V-Lock cord retaining feature as standard.

Product Change Notification					PCN GSP1 New with V-Lock Notch		
owner	creation date	release date	released by	change order no	rev	page	D10-032-636
hollenpe	10.12.2018	14.03.2019	limachcl	2014647	A	1 of 2

Old product appearance	New product appearance with V-Lock notch

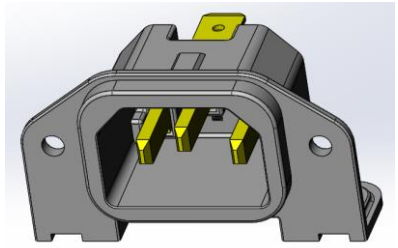
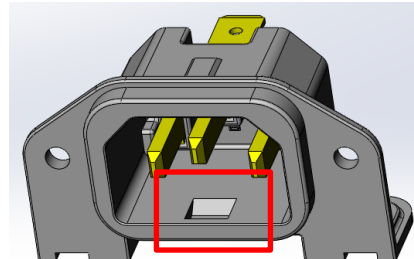
Tooling was updated to include the V-Lock cord retaining feature for all affected part numbers.
